# Central Planning Authority

**Minutes** of a meeting of the Central Planning Authority held on **28 August 2024 at 10:00am** in Conference Room 1038, 1st Floor, Government Administration Building, 133 Elgin Avenue

CPA/22/24

#### ***Planned Roadway Improvements in Vicinity of Subject Lands***

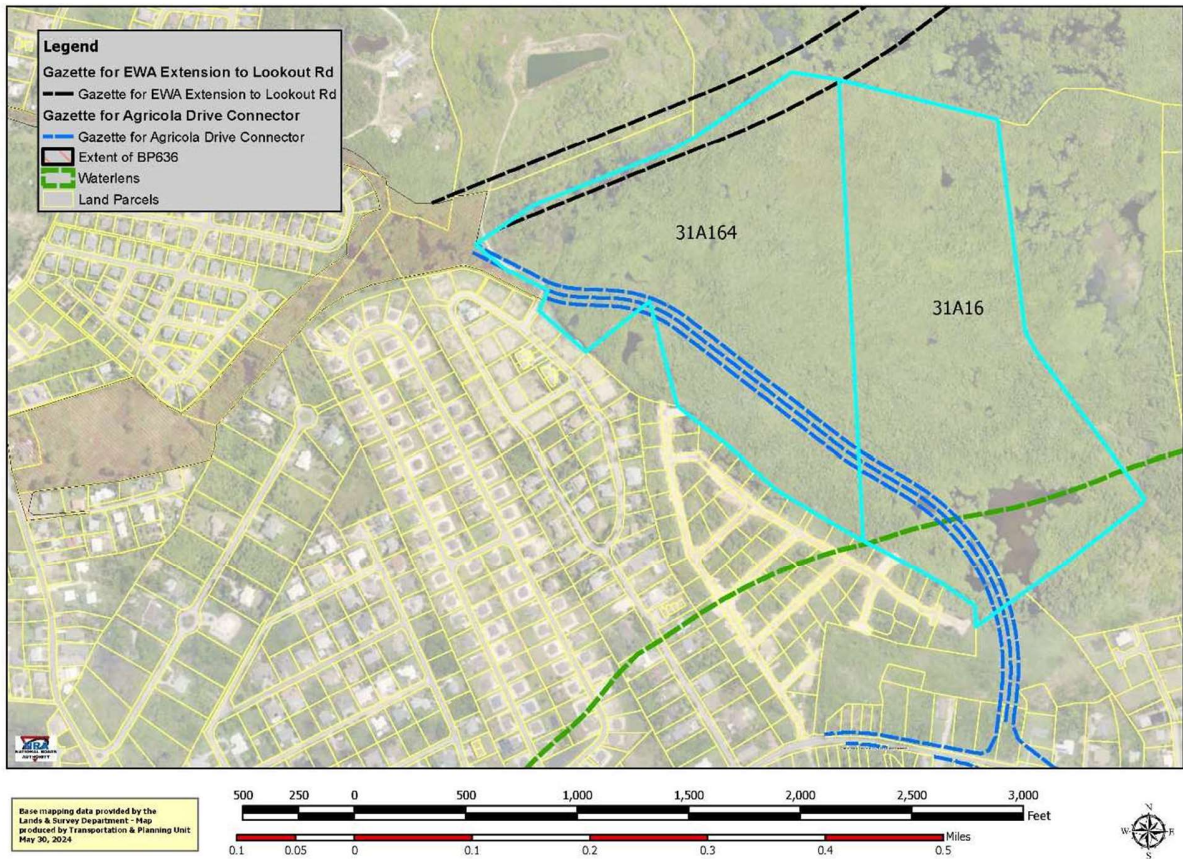
*The NRA is currently undertaking roadworks for the construction of Boundary Plan 636 which is the gazettal of the East-West Arterial (EWA) from Hirst Road to Woodland Drive. These road works are planned to be completed by the end of summer 2024.*

*Per approval by the Ministry of PAHITD, the NRA prepared and submitted gazettal instructions (pursuant to Section 3 and 6 of the Roads Act (2005 Revision) for the Agricola Drive Connector between Shamrock Road and Woodland Drive in early April 2024. The proposed alignment has a planned corridor width of 70 feet, will served as a collector roadway and includes a planned roundabout at the intersection of Shamrock Road with Agricola Drive. The alignment for the planned Agricola Drive Connector was shared with the applicant in mid-2023 and the applicant is respecting the planned corridor as part of the subdivision application. Upon gazettal of the latter roadway, the NRA intends to begin construction in the fall of 2024.*

*Additionally, while the Environmental Impact Study (EIA) for the extension of the East-West Arterial corridor from Woodland Drive to Frank Sound Road is still on-going, the alignment and width of this planned road corridor is now essentially been set at 220 feet — the findings*

**Figure 1: UK Hydrographic Office 2021 aerial image showing the subject parcels highlighted in light blue. Note that the parcels consist of seasonally flooded mangrove forests and woodland. The filling of this habitat has the potential to impact surrounding residential areas.**

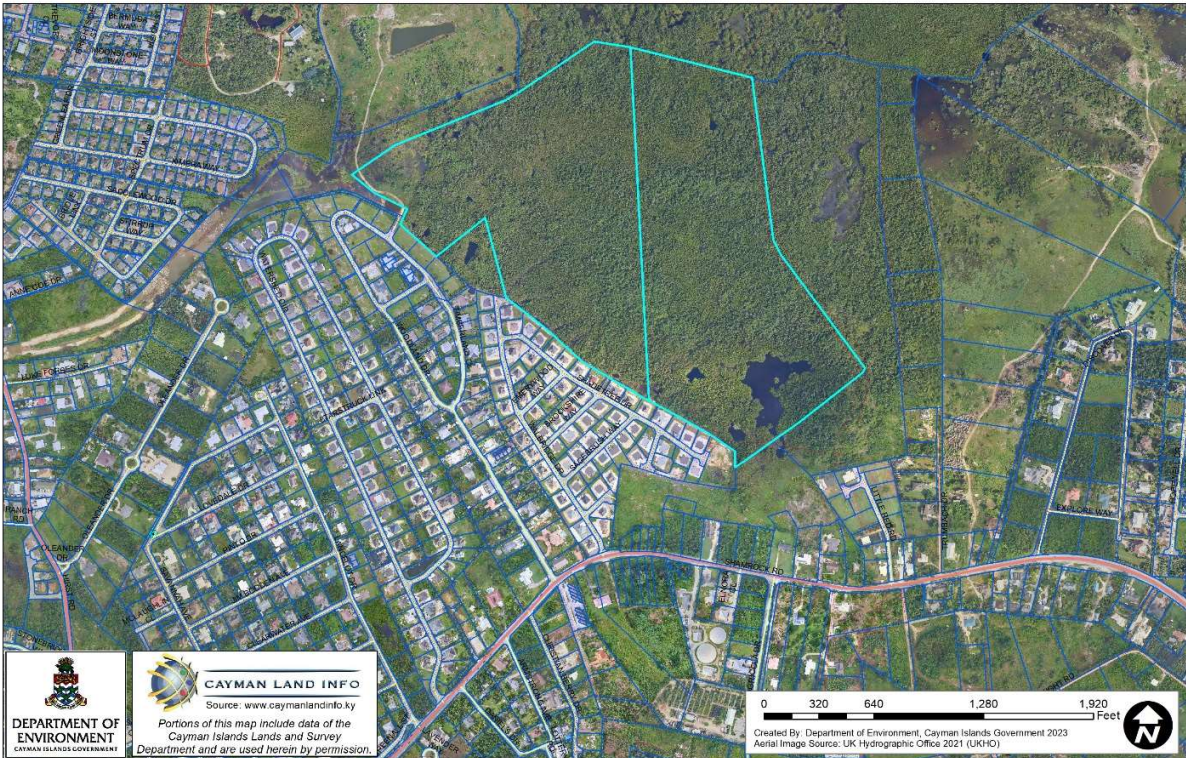
We note that the proposed subdivision plan references the East-West Arterial road and Savannah By-Pass Connector (shown as "Proposed NRA take" on the applicant's site plan). The East-West Arterial road is currently the subject of an ongoing Environmental Impact Assessment (EIA), due to the potential effects on flooding and drainage of nearby communities and the hydrology and ecology of the Central Mangrove Wetlands. The EIA will help to refine the specific route of the road and will determine the design required to maintain a suitable hydrological regime. The outcome of the EIA also has the potential to affect current and proposed land-use along the road corridor; for example, the EIA may recommend stormwater management techniques such as the requirement of retention ponds in specific areas.

*The applicant’s site plan shows the retention of an existing pond on-site on Block 31A Parcel 16. In future, it will be essential to ensure that stormwater does not run off into the pond as this could lead to eutrophication of the pond and associated poor water quality impacts and amenity issues. Ponds can also be susceptible to contamination from neighbouring septic tanks and the use of fertilizer during landscaping maintenance.*

*As water quality is also impacted by the surrounding uses, efforts should be made to ensure that any activities that have the potential to increase the level of nutrients entering the pond are avoided and/or minimised. The DoE strongly recommends that there is no direct stormwater discharge into the pond. In addition, the applicant is encouraged to retain any existing pond-side vegetation including mangroves and to incorporate a vegetated buffer around the pond to assist with reducing water quality impacts. Retaining the pond-side mangroves would provide a natural buffer which will help intercept surface water that may run off of the land into the pond.*
